VARIANCE REQUEST

Iowa Department of Natural Resources

1. Date: June 16, 2003
2. Review Engineer: Larry Bryant
3. Date Received: May 16, 2003
4. Facility Name: City of Eagle Grove WWTP
5. County Number: 99 (Wright)
6. Program Area: CP (Wastewater Construction)
7. Facility Type : C05 (Biological Treatment)
8. Subject Area : 401 (Flow Splitting)
9. Rule Reference: 567-64.2(9)a
10. Design Stds Ref: 14.4.9.2; 14.4.9.3; 18A.7.4.5(a) (Flexibility;
Flow Division Control; Flow Control)
11. Consulting Engr: Kuehl & Payer, Ltd.
12. Variance Rule: 567-64.2(9)c

RE: Variance Requests - Wastewater Treatment Plant Improvements

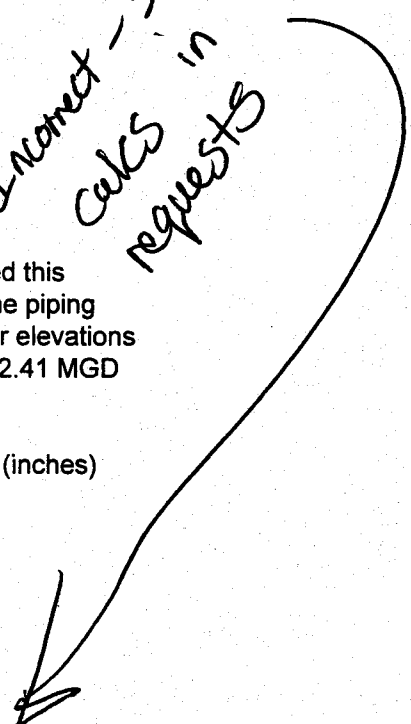
7. This is a tough one. It's been awhile since I've performed this type of hydraulic calculation but I gave it a try. Assuming the piping layout as shown on the plans and that the RBC effluent weir elevations are set the same, I get the following splits at the 0.841 and 2.41 MGD design flows:

I agree that the losses aren't that big, particularly between the 2nd

*Incorrect - see revised
calcs in variance
requests*

and 3rd units, but at least in theory they have a pretty dramatic effect on the flow split. Although I haven't gone through the calculations for just the existing units, I would guess that they aren't getting even flow splits with the current arrangement.
